Re: Williamson County Emergency Services Operations Center CM
Job No: 172201

Subj: Change Proposal No. 172201-0022

Proposal Request #011

446431-A-202

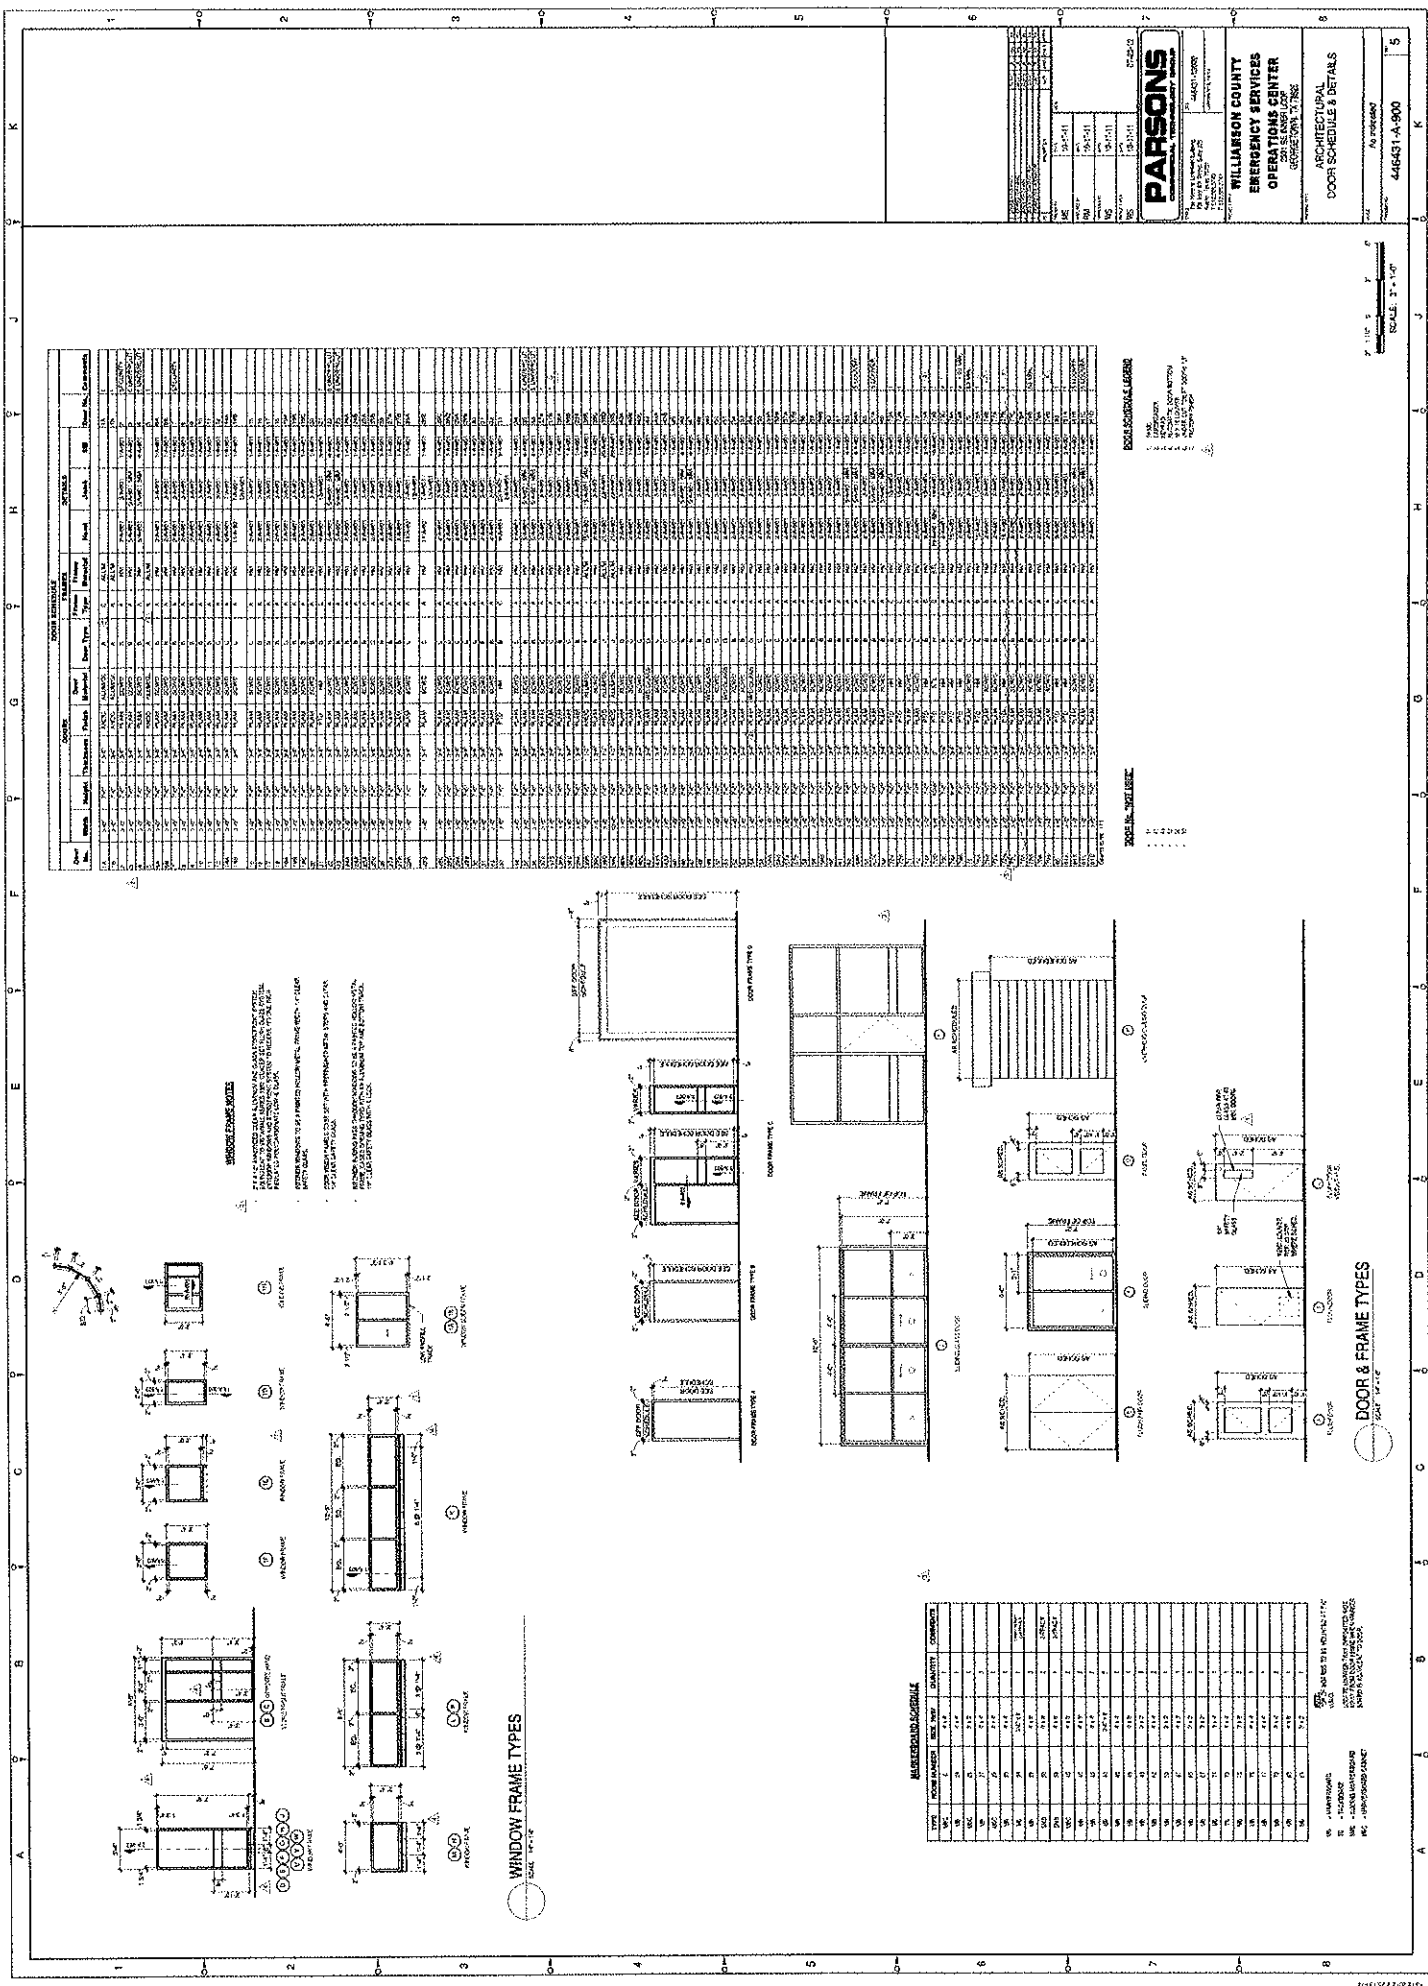
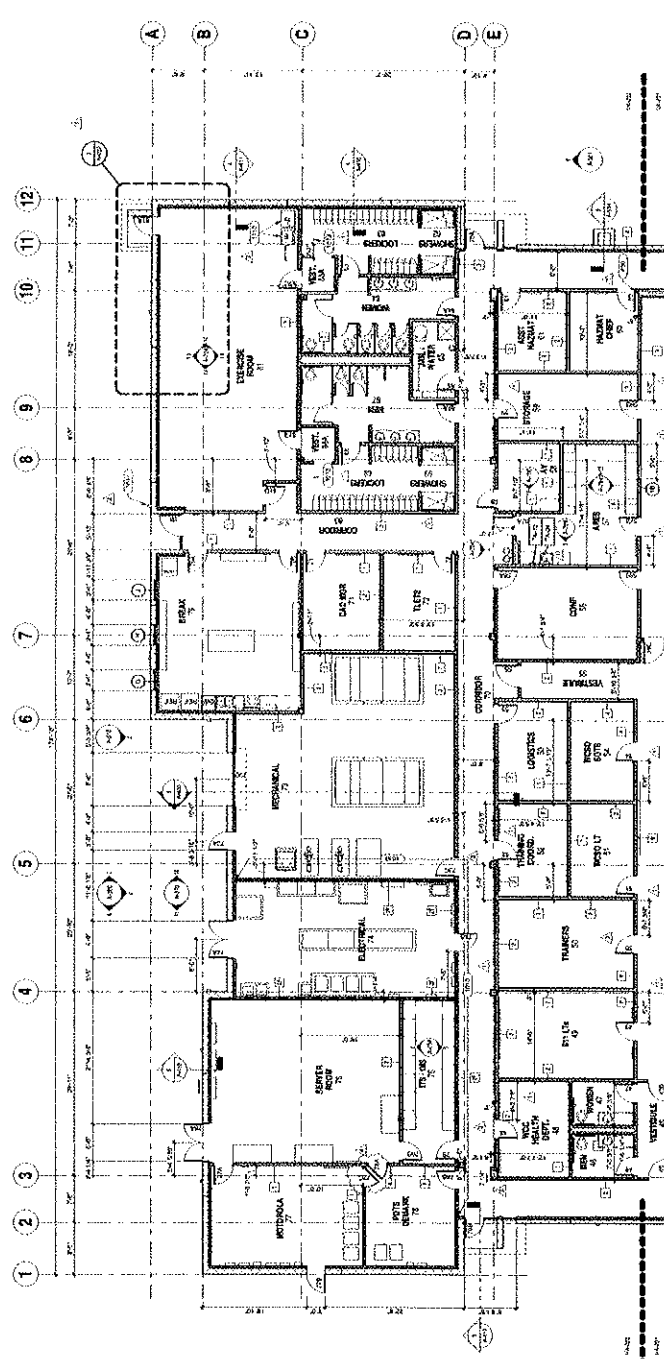
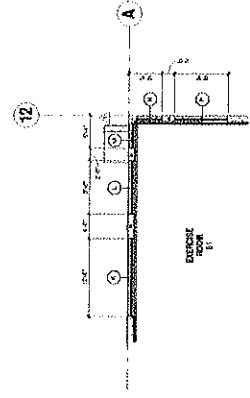
Add door 77C between POTS/DMARK 78 and MOTOROLA 77. Revise hardware per below.

A-202 & A-900 dated October 12, 2012
